~~12 July 2022~~ **3 August 2022**

~~ISSUE FOR BID~~ **Bid Addendum 3**

Nyack Union Free School District
Hilltop Professional Development Center

DEMOLITION PLAN

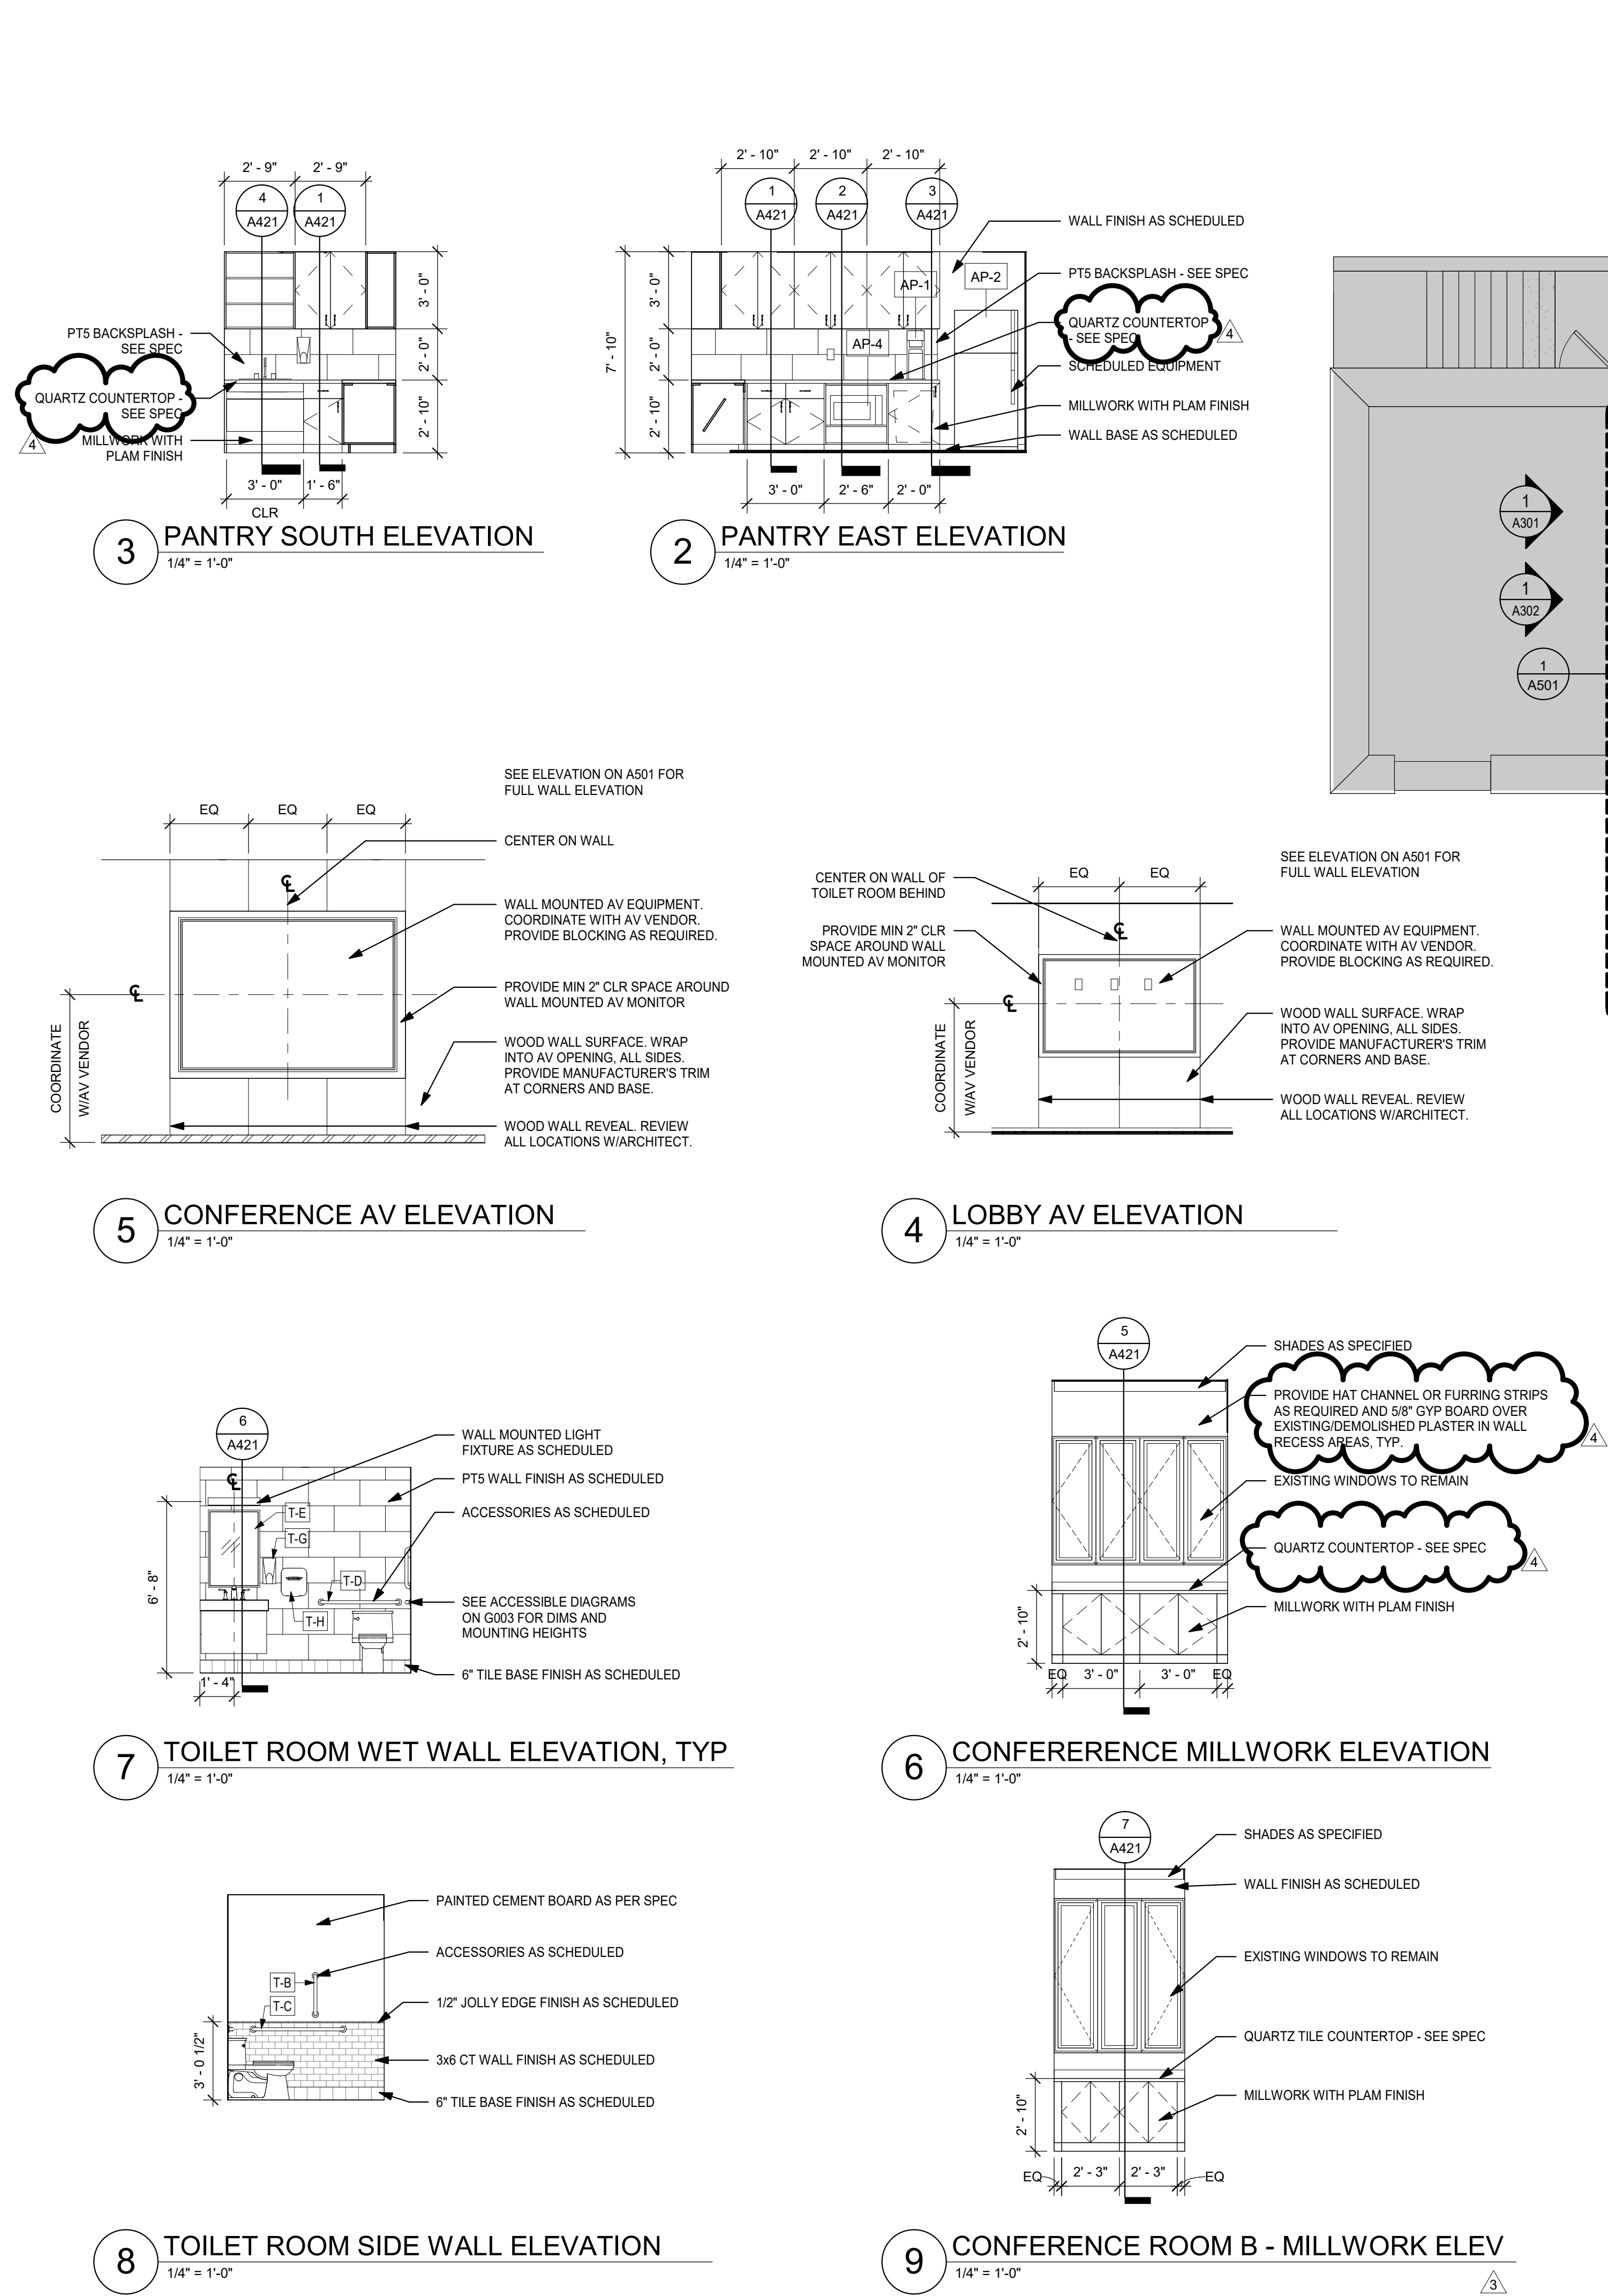
1. Sheet G001 GENERAL INFORMATION is being REISSUED.
2. Sheet A101 DEMOLITION PLAN has been REVISED to include a note regarding location of existing rubber fitness room flooring. Additional notes regarding demolition along and preparation of the existing perimeter walls in Conference Rooms has been ADDED.
3. On Sheet A201 FLOOR PLAN & INTERIOR ELEVATIONS, REMOVE the word "TILE" from elevations calling for QUARTZ TILE COUNTERTOP. Refer to specifications for information on the countertops. Refer to notes on Detail 6 regarding new GWB surrounds in window areas. FFE Schedule has been REVISED.
4. General Note 5 on sheet A911 DOOR SCHEDULE, DOOR & FRAME TYPES has been ADDED.

- 10 REMOVE STEEL SLAT ROLL UP DOOR
- 11 STAIRS TO REMAIN. PREP TO RECEIVE NEW FINISHES AS SCHEDULED.
- 25 LOCATION OF EXISTING RUBBER FLOORING ON +/- 1" HIGH ELEVATED WOOD PLATFORM TO BE REMOVED. GC TO COORDINATE DEMOLITION AND ABATEMENT AS REQUIRED PER SPECIFICATIONS.

DOOR TYPES

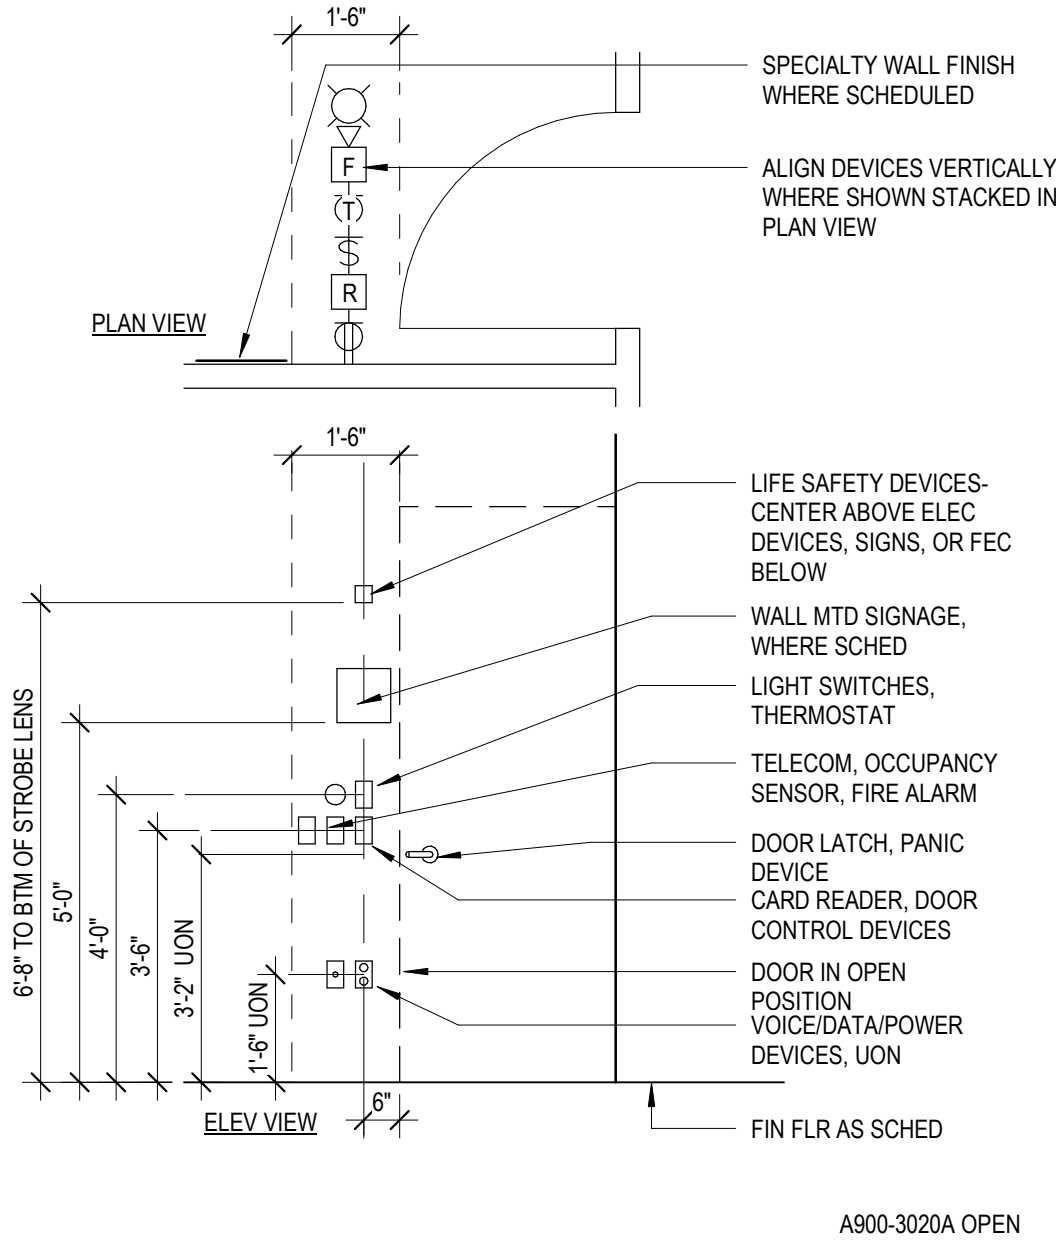
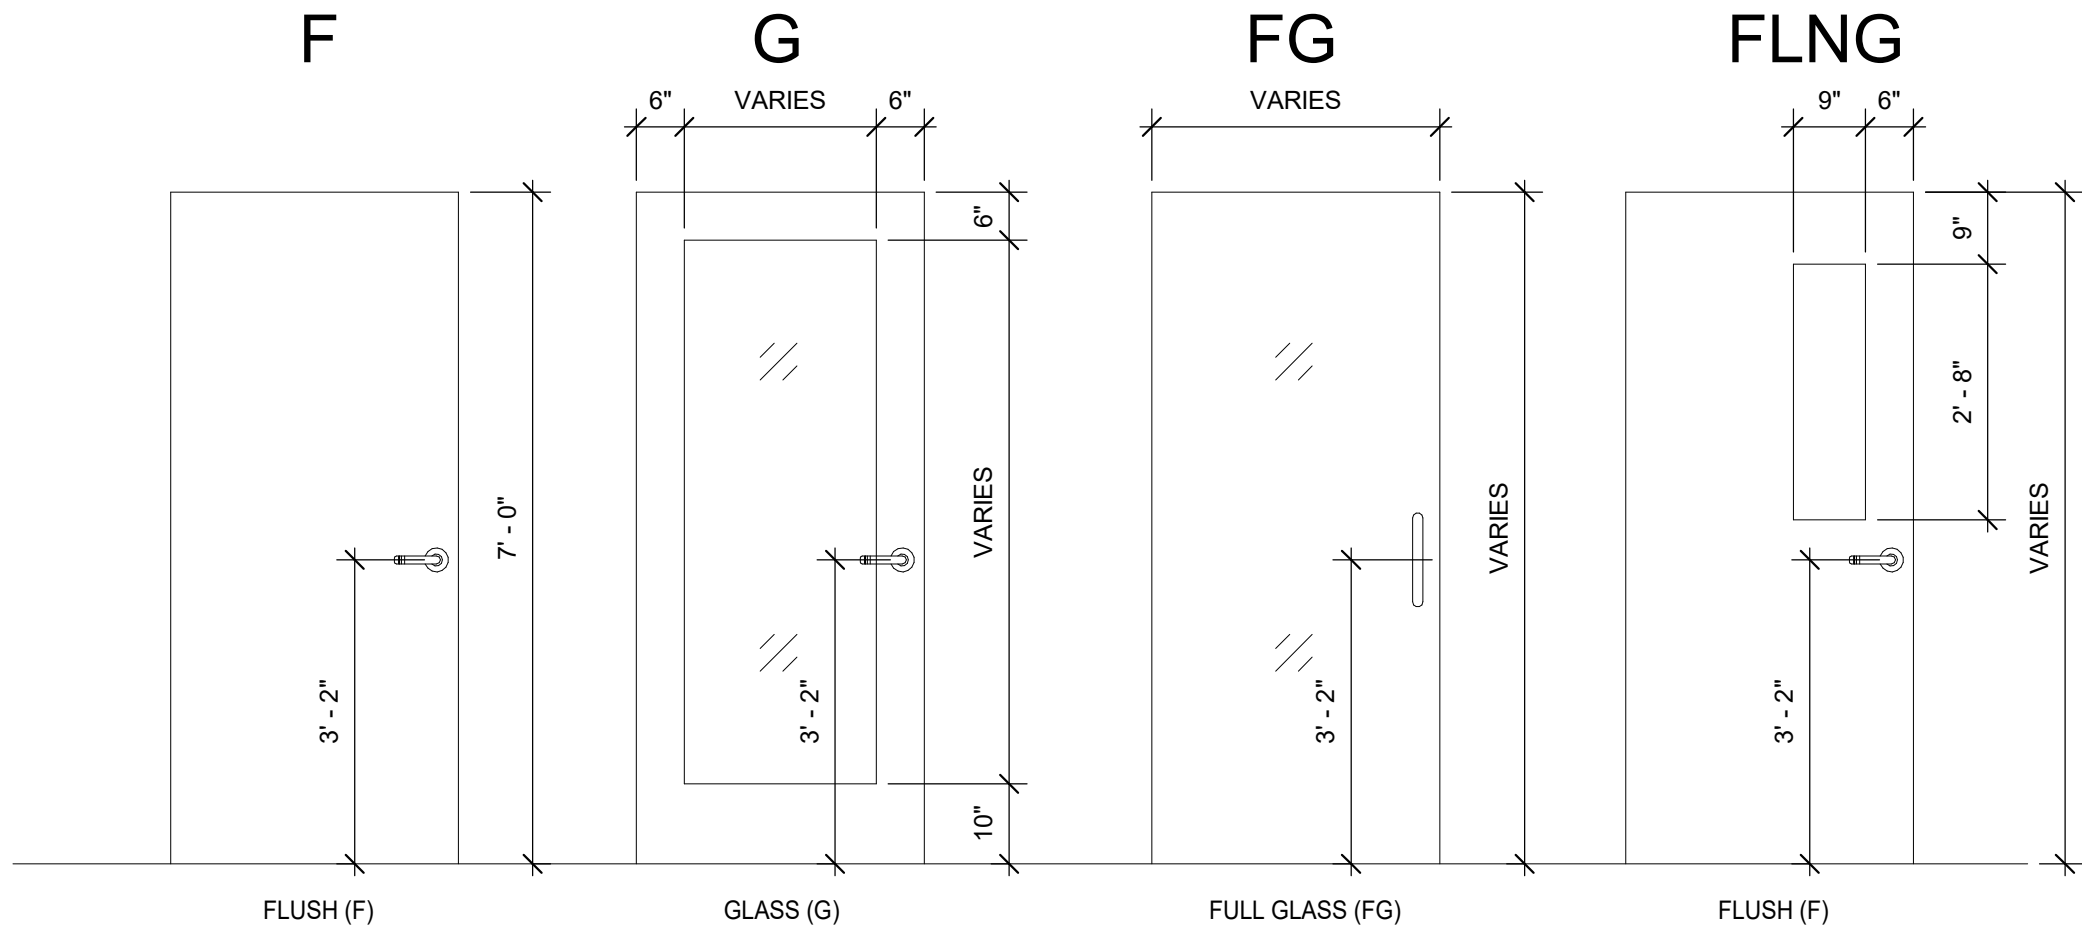
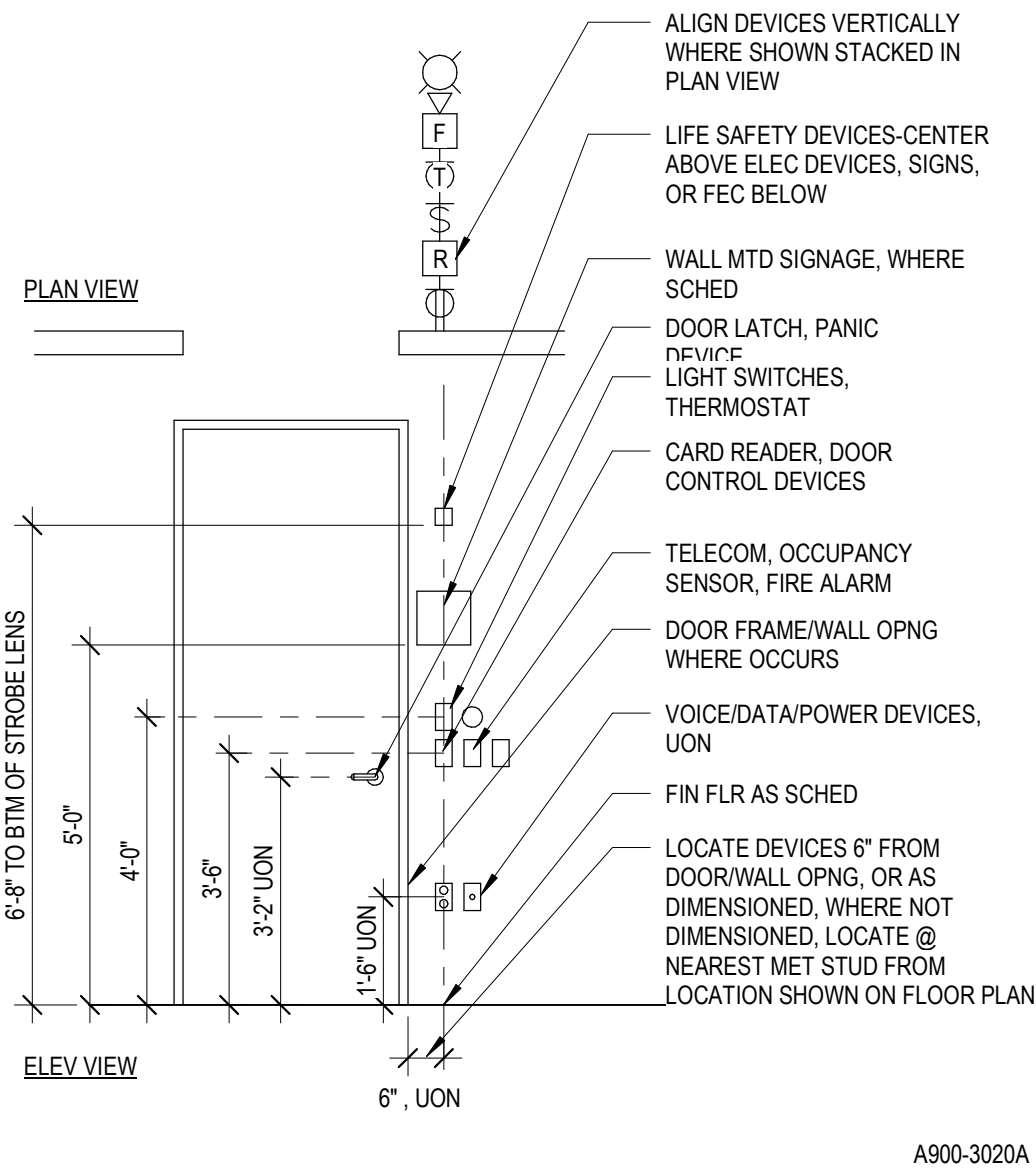
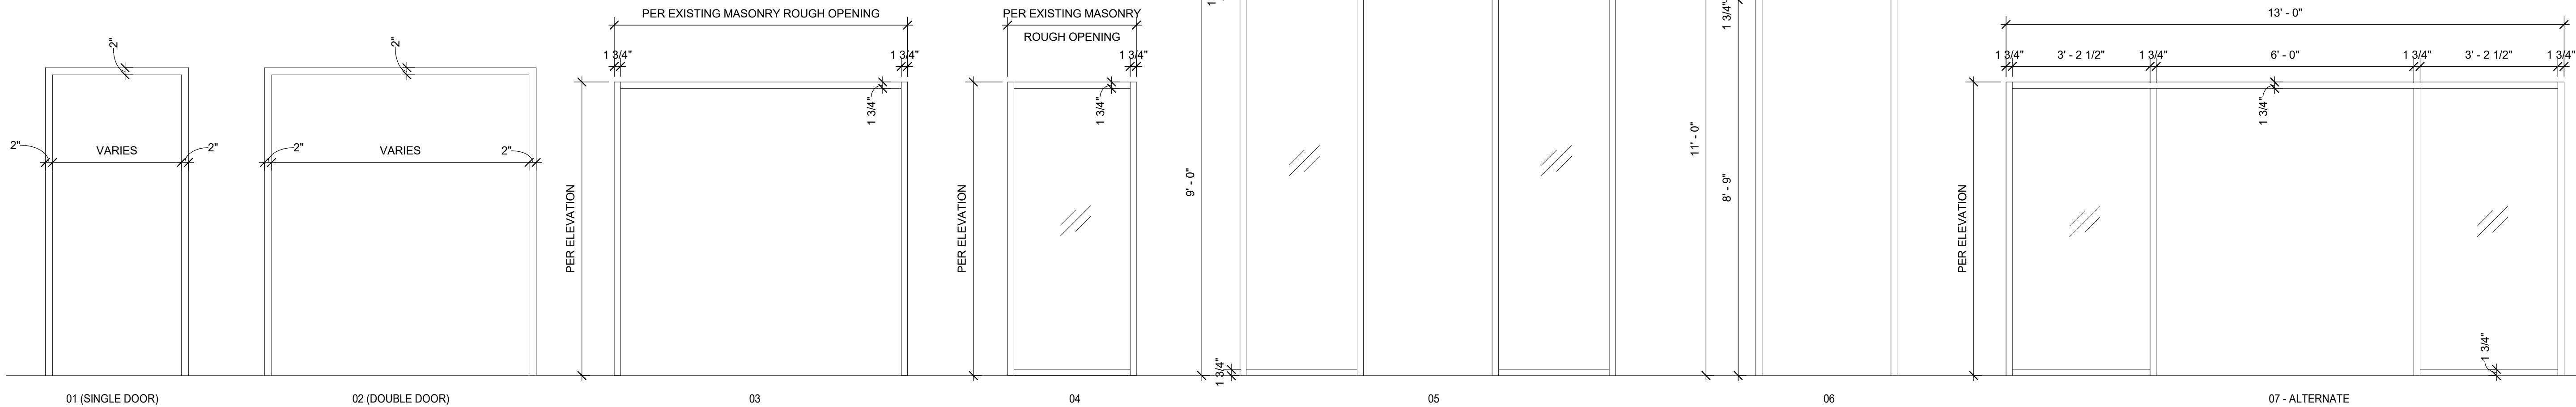
2. Door 101X shall have hardware set 1.0 per specification section 087101 DOOR HARDWARE SCHEDULE. This double door should have two equal leaves.
3. See image included in this addendum showing existing transoms over doors 110C and 110D to be replaced.
